SALEM GENERATING STATION
EVENT CLASSIFICATION GUIDE TECHNICAL BASIS
April 19, 2002

CHANGE PAGES FOR
REVISION #13

11.3 System Actuations

SYSTEM ACTUATION FLOW CHART

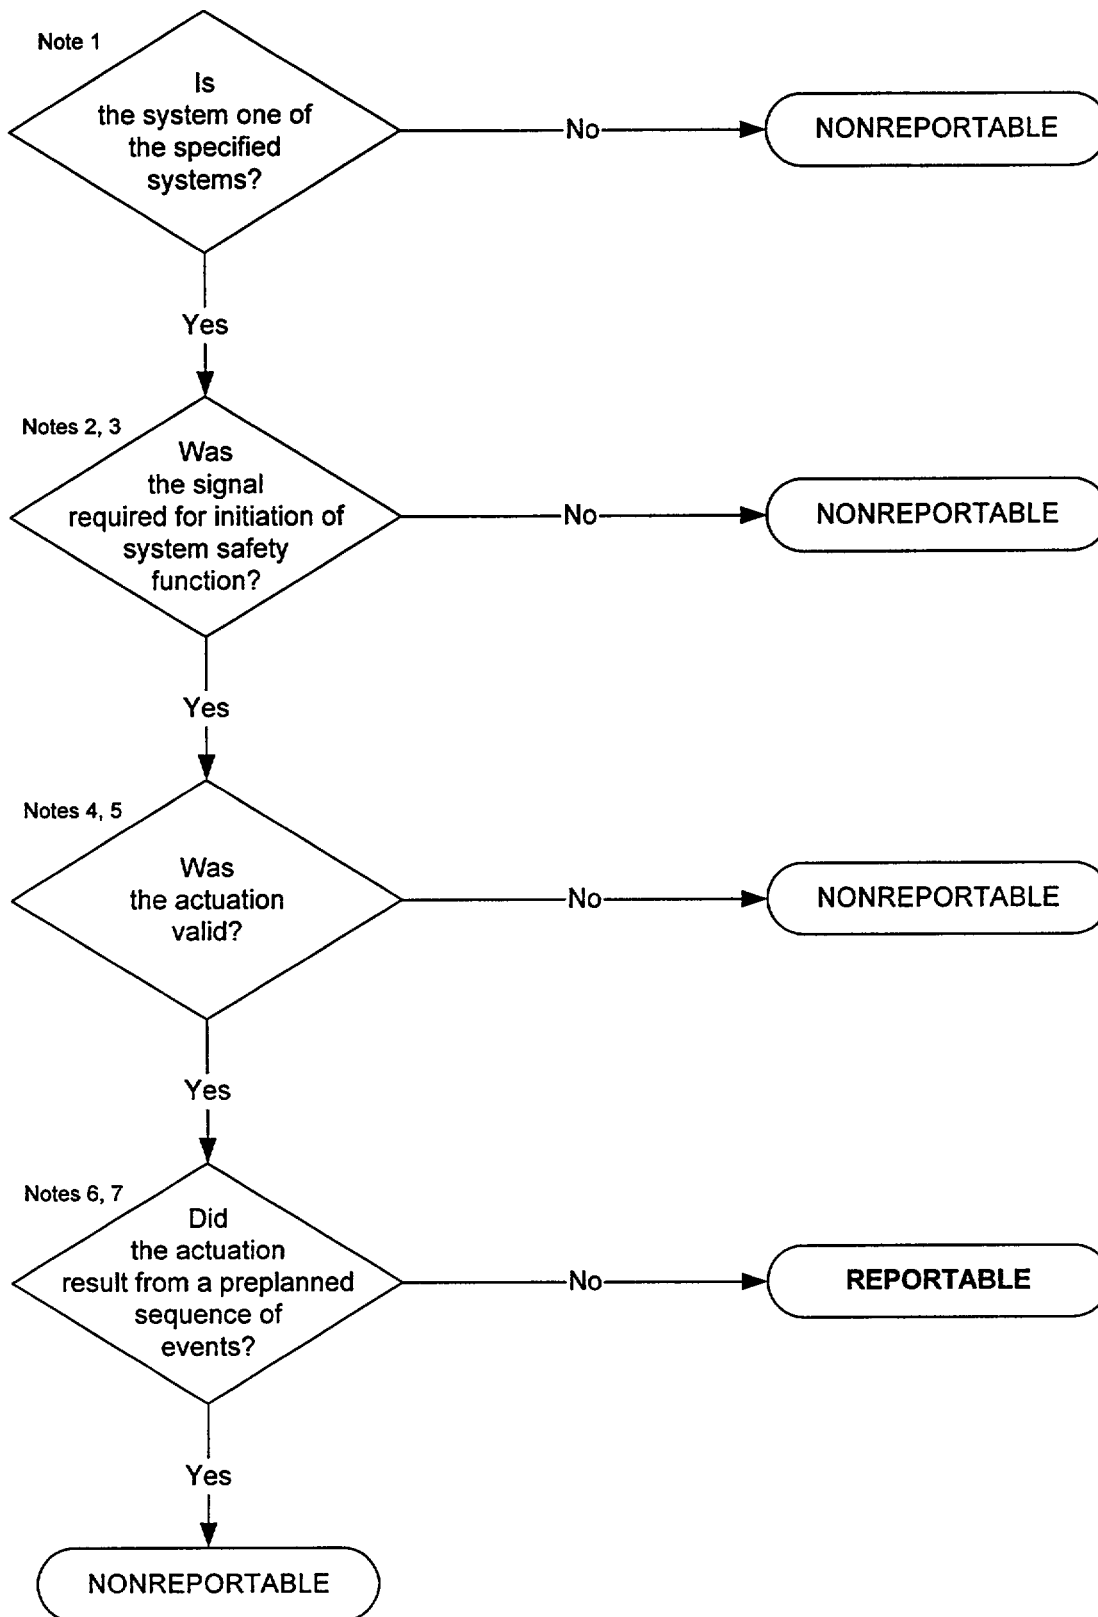
- 11.3.3 Technical Basis - added statement that an actuation cannot be considered invalid if it results from an actual system parameter reaching its set point.

5. Invalid actuations are by definition those that do not meet the criteria for being valid. Invalid actuations can include instrument drift, spurious signals, human error, jarring a cabinet, an error in the use of jumpers or lifted leads, an error in the actuation of switches or controls, equipment failure, or radio frequency interference. Invalid actuations do not include actuations from the sensor by measurement of an actual physical system parameter that was at its setpoint.
